CITY OF LA VISTA
MAYOR AND CITY COUNCIL REPORT
DECEMBER 7, 2021 AGENDA

Subject:	Type:	Submitted By:
APPLICATION FOR PUD SITE PLAN AND REPLAT. LOT 19 SOUTHPORT WEST AND LOTS 1-3 SOUTHPORT WEST REPLAT 7	◆ RESOLUTION (2) ORDINANCE RECEIVE/FILE	CHRISTOPHER SOLBERG DEPUTY COMMUNITY DEVELOPMENT DIRECTOR

**CITY OF LA VISTA
PLANNING DIVISION
RECOMMENDATION REPORT**

RE: Planned Unit Development Amendment – Initial Review Letter
Lots 1, 2, and 3 Southport West Replat 7 and Lot 19 Southport West

PHASING MAP

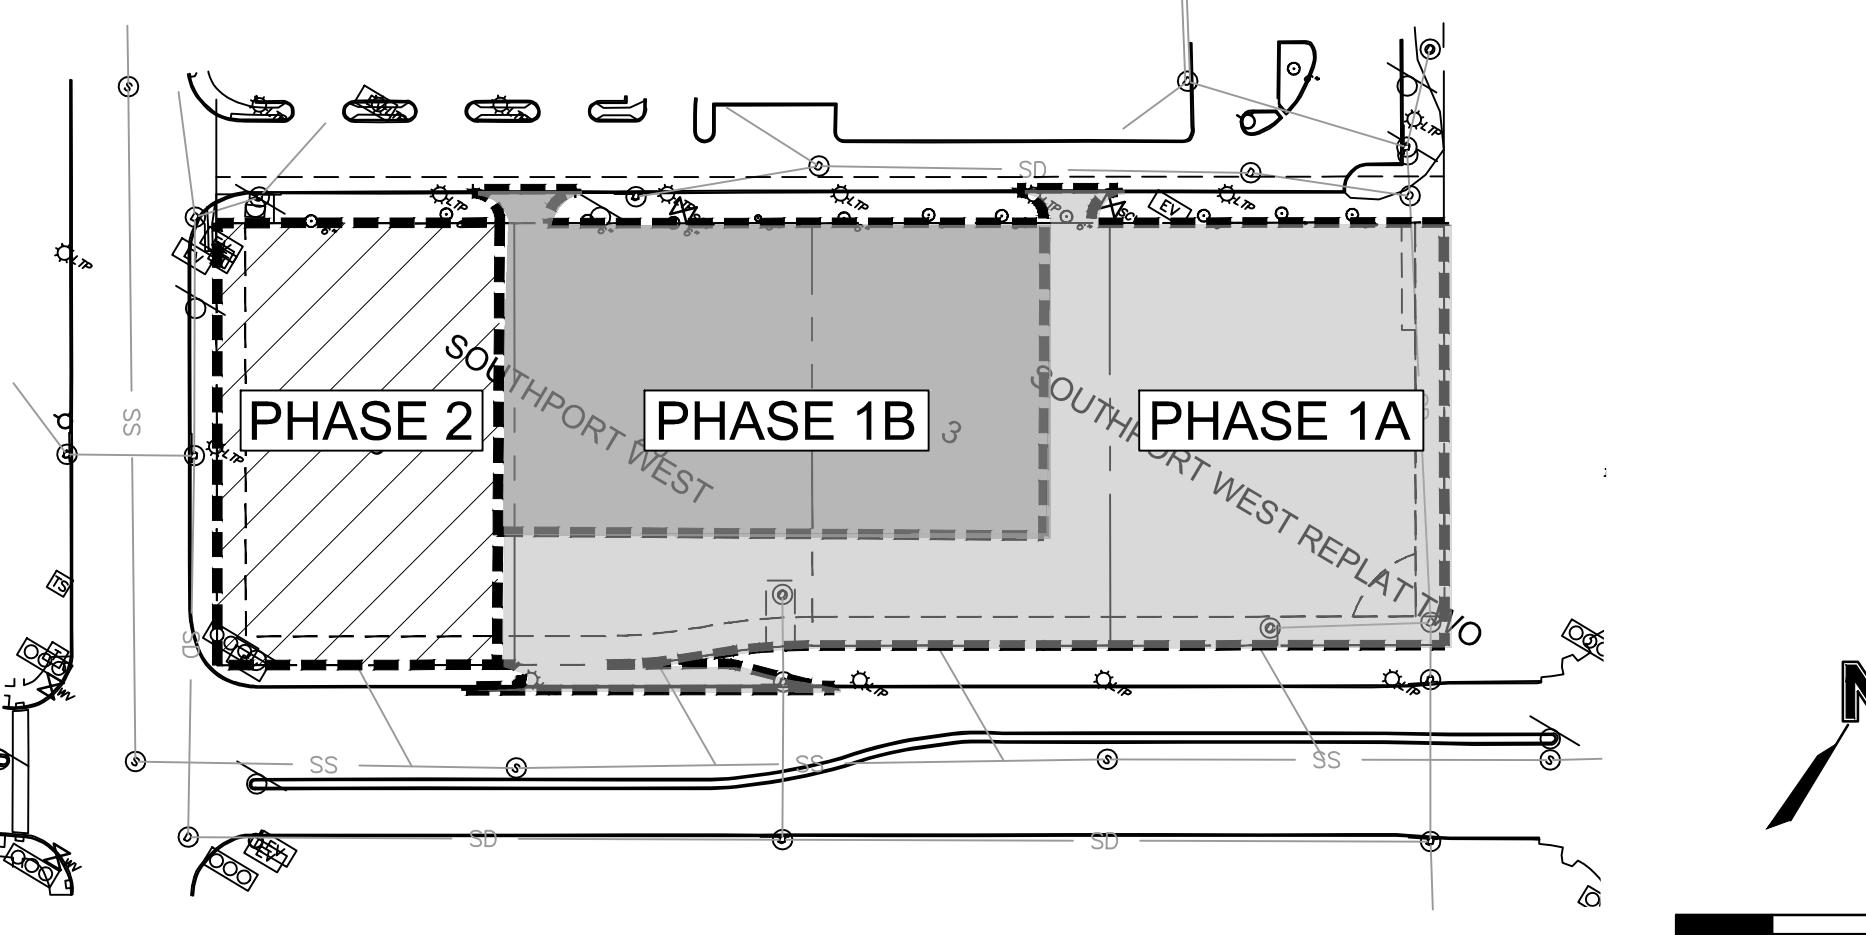
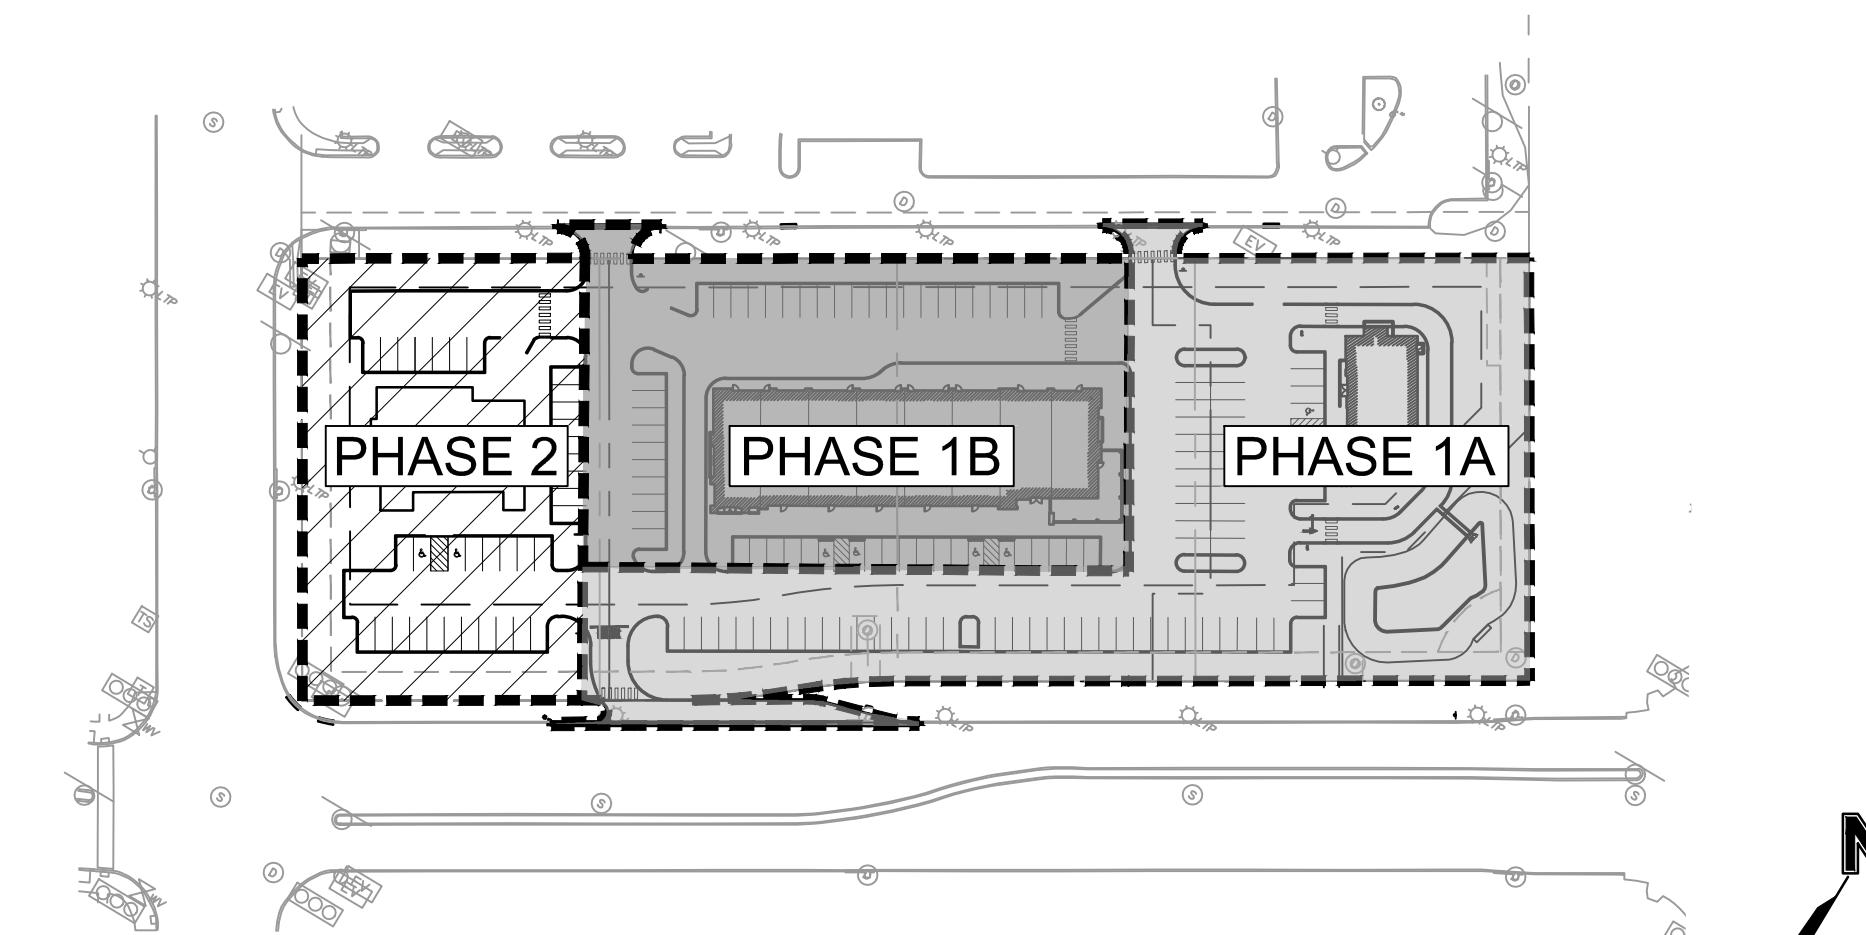
2. Please provide an updated PUD plan set to include the following additional changes:
 - a. Please add the phasing map into the most current PUD plan set.
 - b. Please add the setback dimension from the northernmost corner of the dumpster enclosure on proposed Lot 2 to the property line.

C3.1

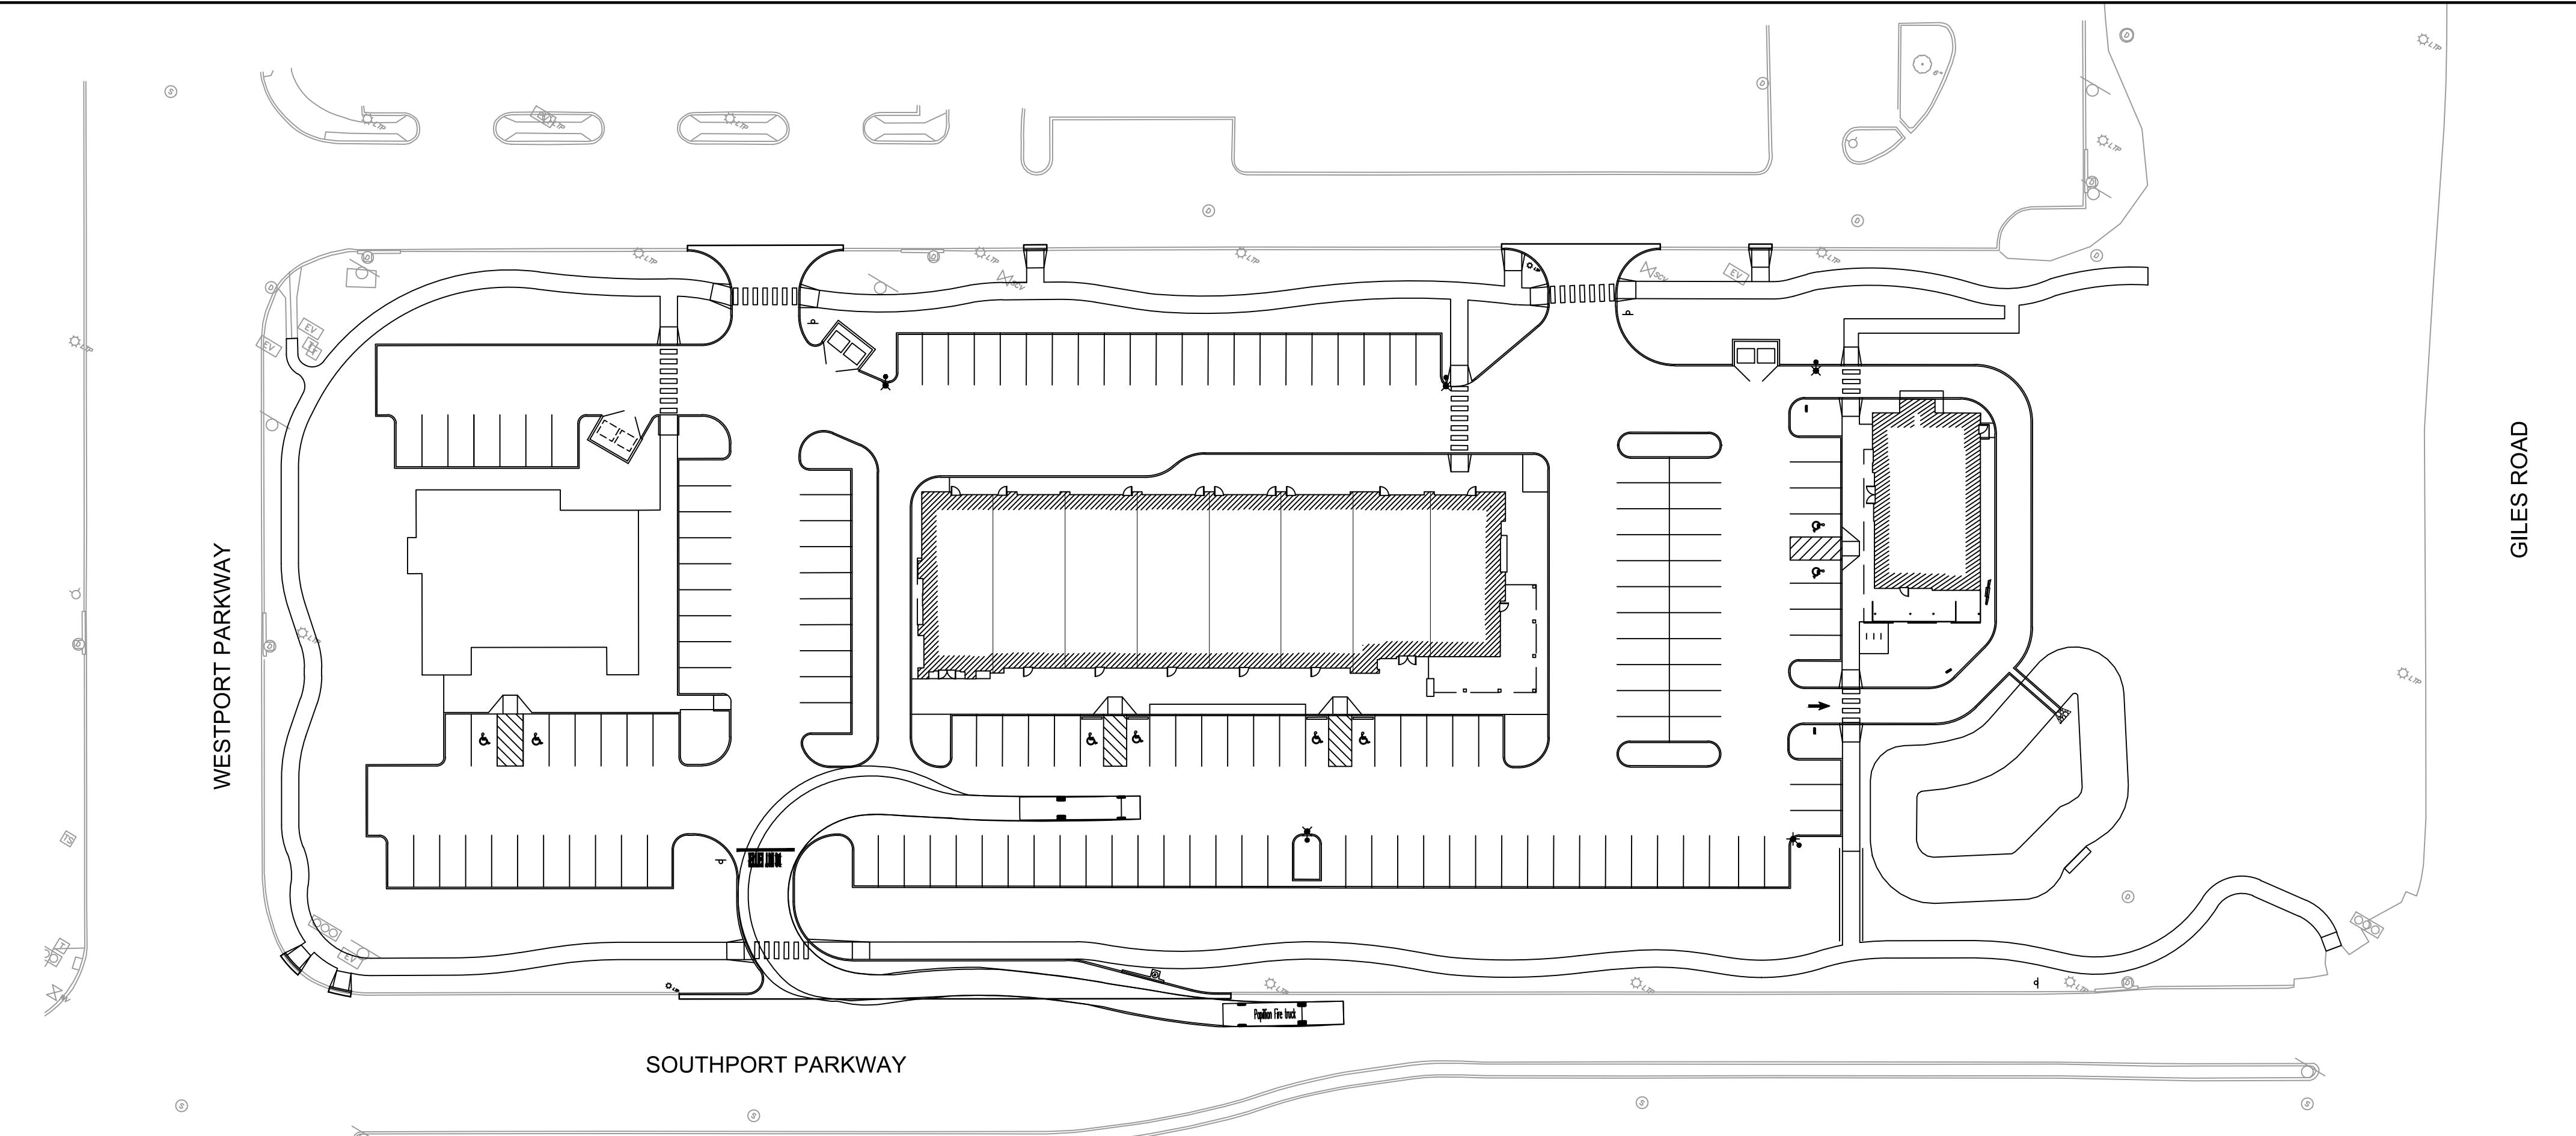
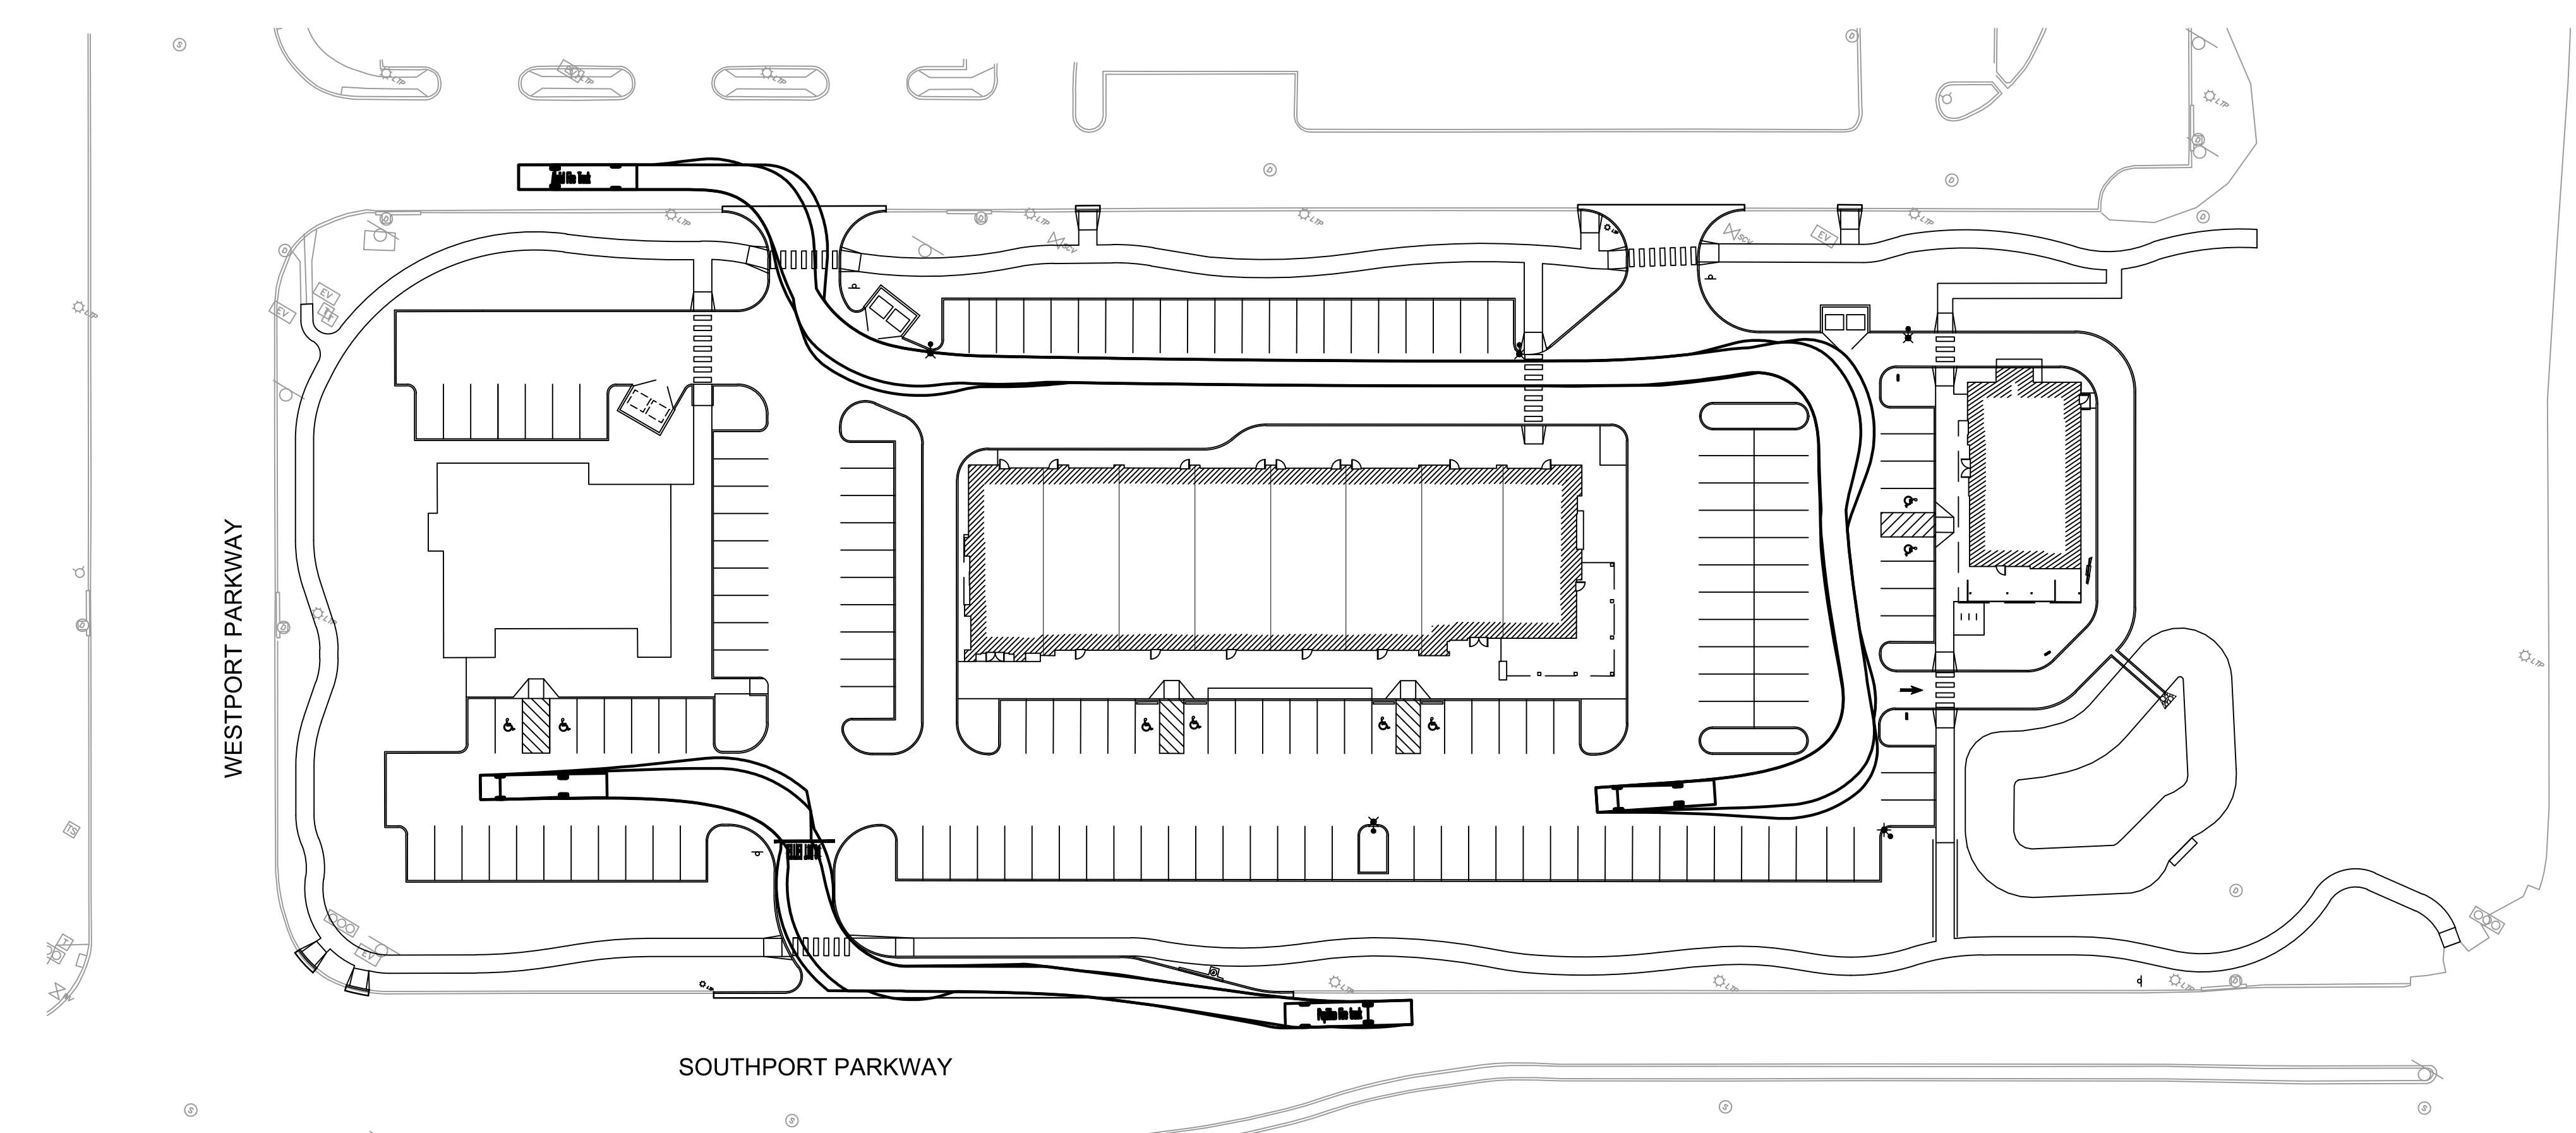
1. Grading work will require a grading permit. Please reach out to La Vista's Chief Building Official, Jeff Sinnott, at (402) 593-6400 for information on how to obtain your grading permit prior to the start of any grading.
2. As there are drainage capacity limitations at the culvert crossing near and under the rail road southeast of Giles road, all catchment drains that drain into said basin should be held to a no-net increase of the predevelopment flows until the drainage culverts at the railroad is up-sized to account for post-developed conditions for a 100-year return frequency.
